MODIFICATION APPLICATION

LEVEL 4 - SERVICE VEHICLE ZONE REVISED PLAN (PHASE A)

RPAC
26 ALBION STREET WAVERLEY NSW 2024

REVISED ELEVATION - EAST
STAGE 1 (PHASE A)

DETAIL 2 - REVISED EAST ELEVATION - EAST (SERVICE VEHICLE ZONE) STAGE 1 - PHASE A
1:100

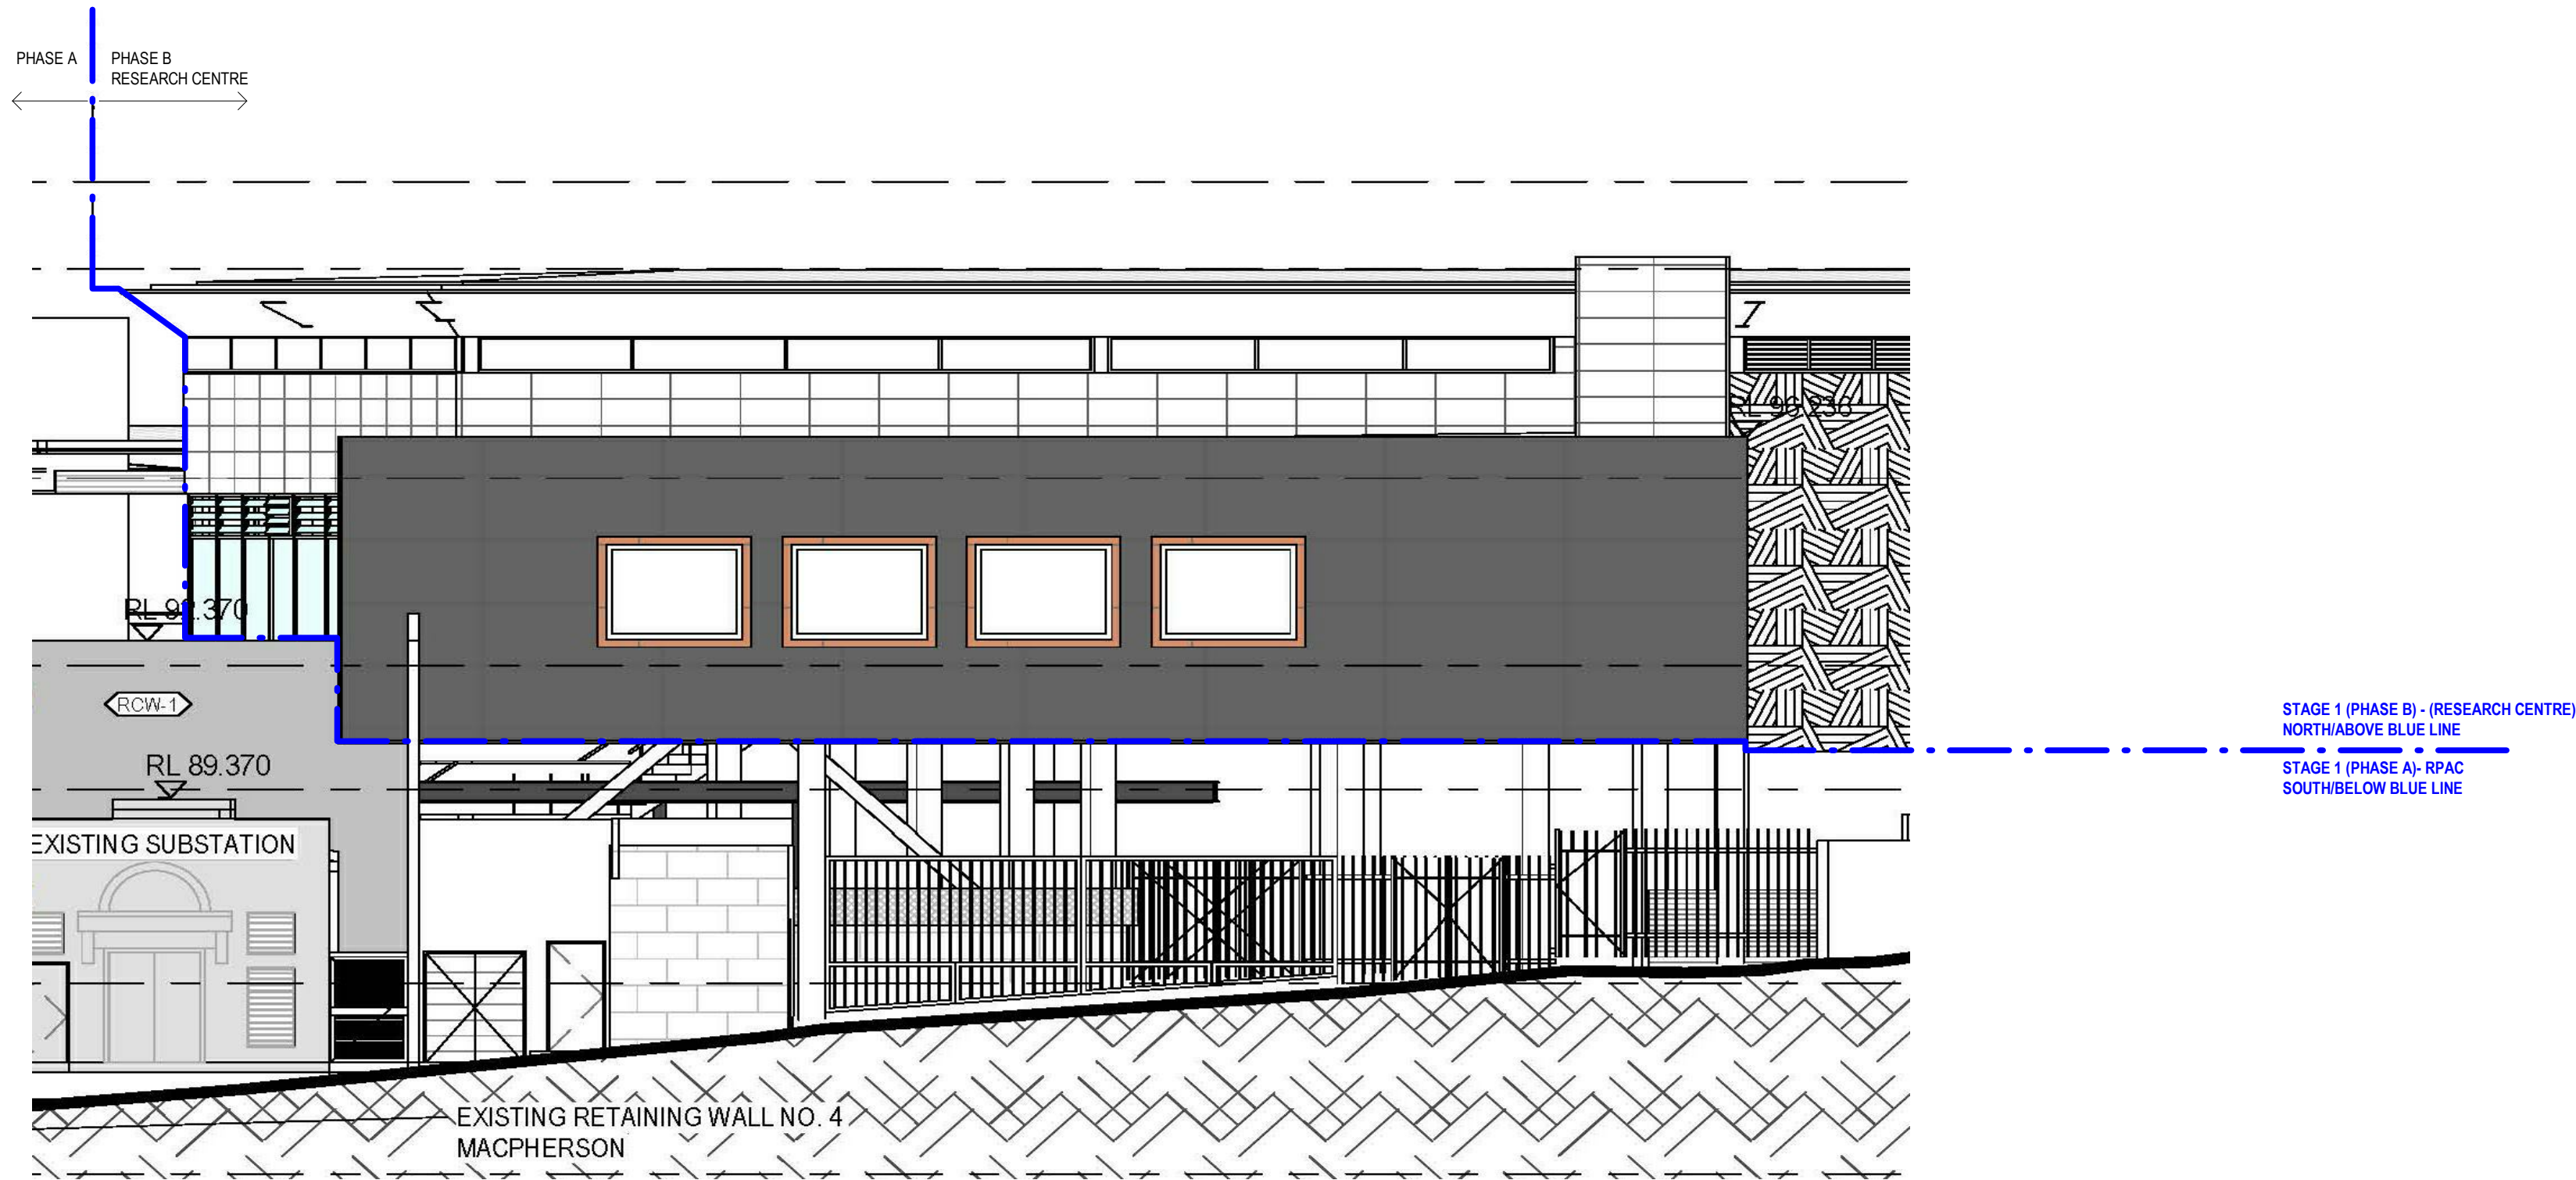
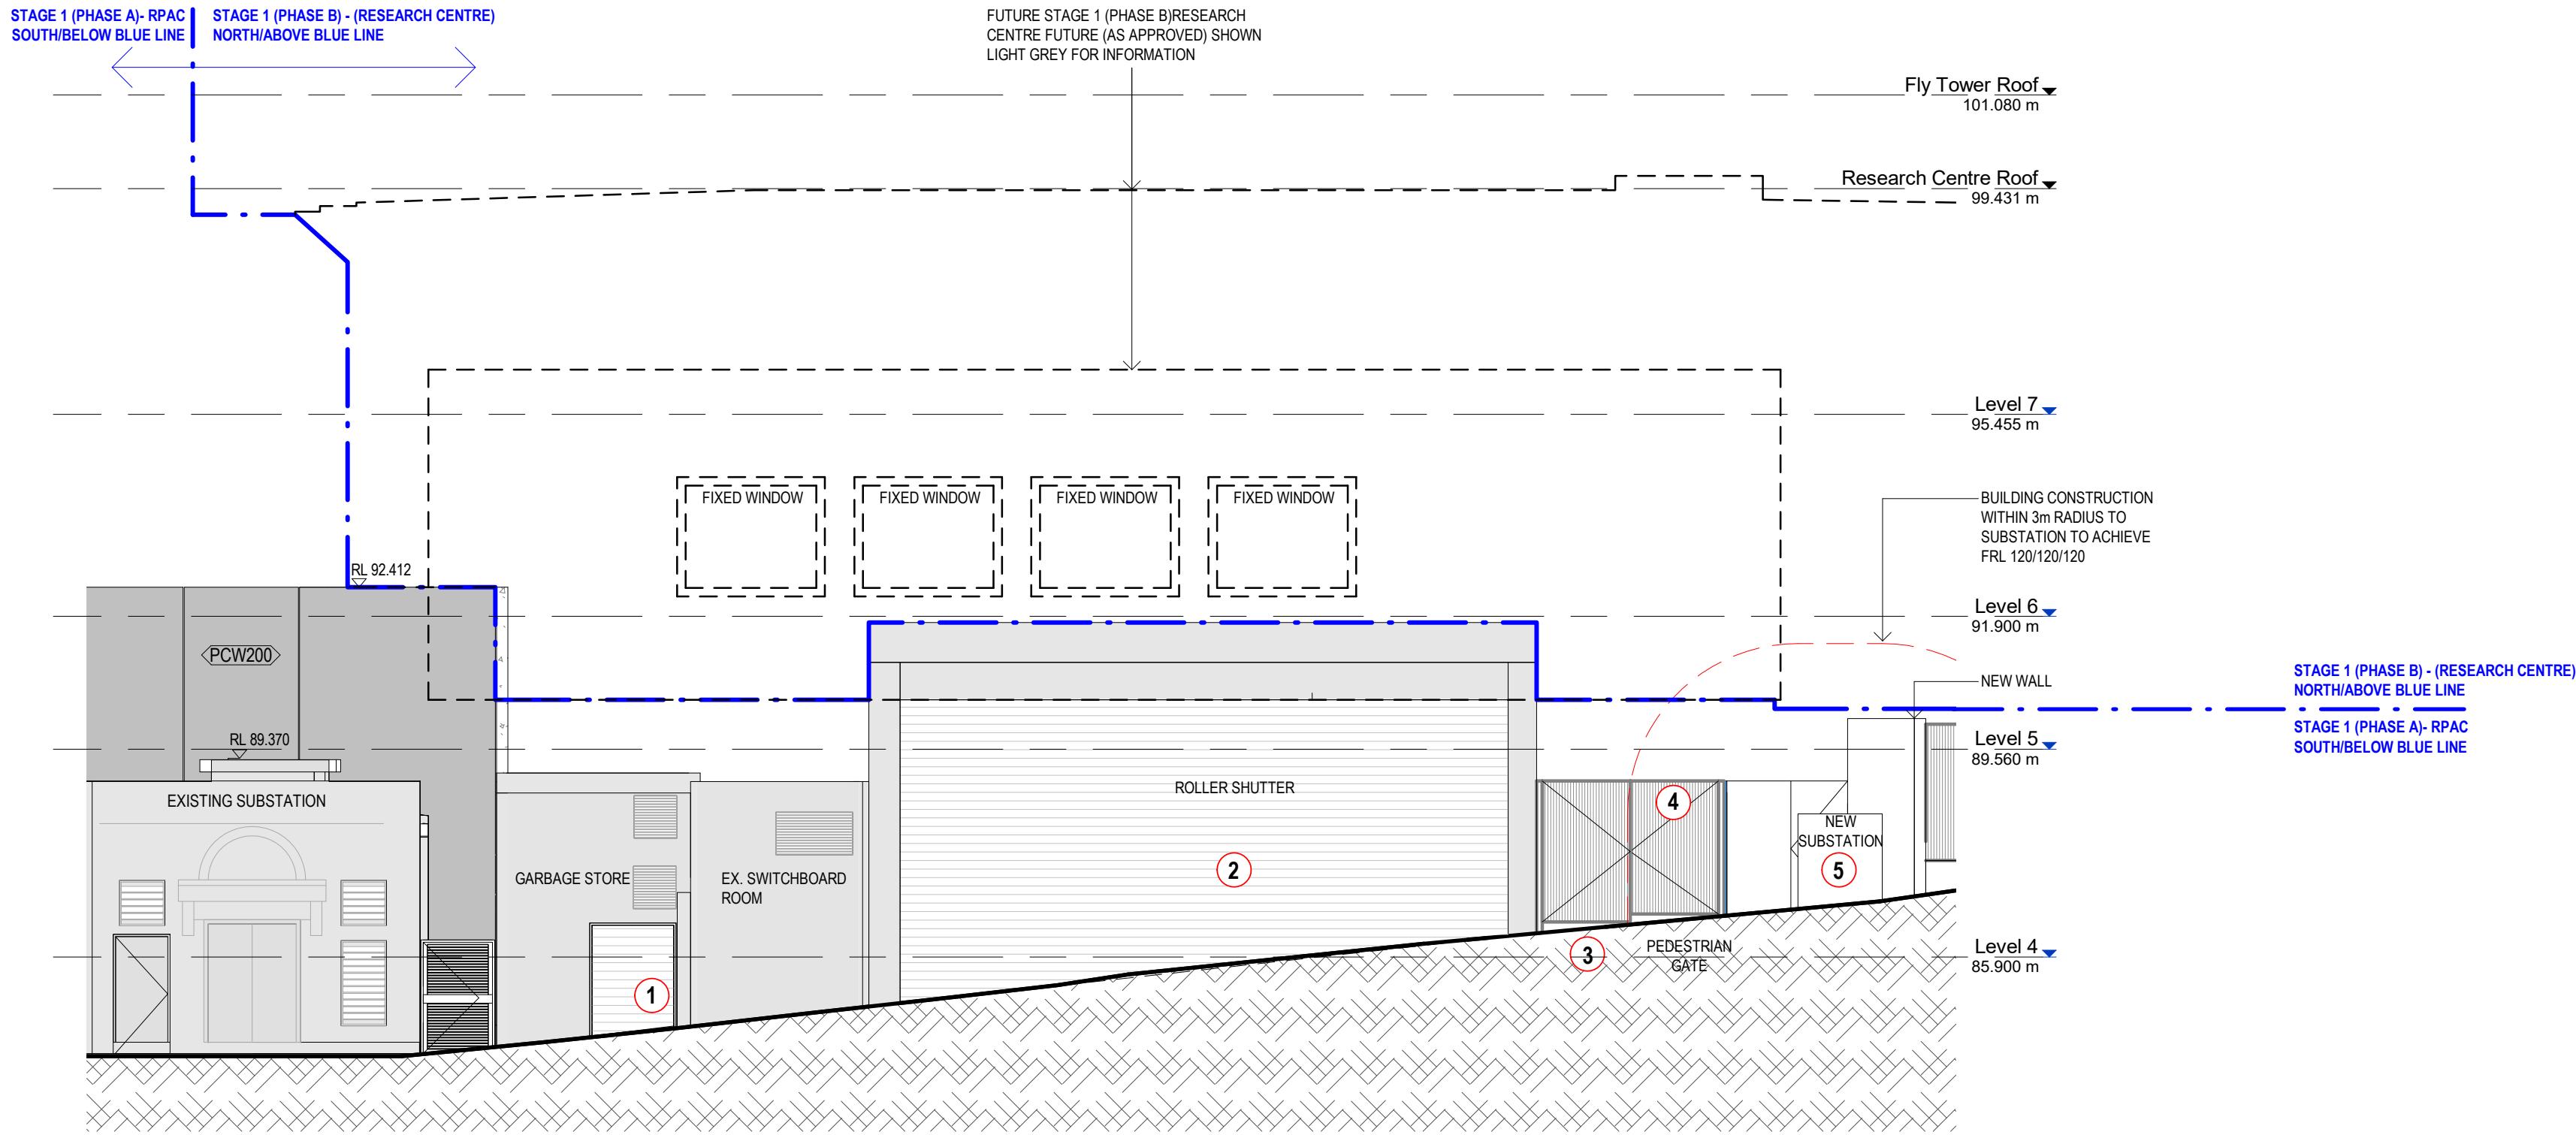
- LIST OF REVISED ITEMS: ELEVATION
- CO2 ROOM DELETED AS NO LONGER REQUIRED.
 - VEHICULAR GATE SWING DOORS REPLACED BY ROLLER SHUTTER FOR A MORE ADEQUATE AND SAFE CIRCULATION ENTRY/EXIT OF VEHICLES.
 - INTERNAL FENCE & ASSOCIATED GATE DELETED AS NO LONGER REQUIRED.
 - PEDESTRIAN GATE RELOCATED FOR IMPROVED FUNCTIONALITY.
 - NEW SUBSTATION RELOCATED FROM ALBION STREET TO LEICHHARDT LANE.
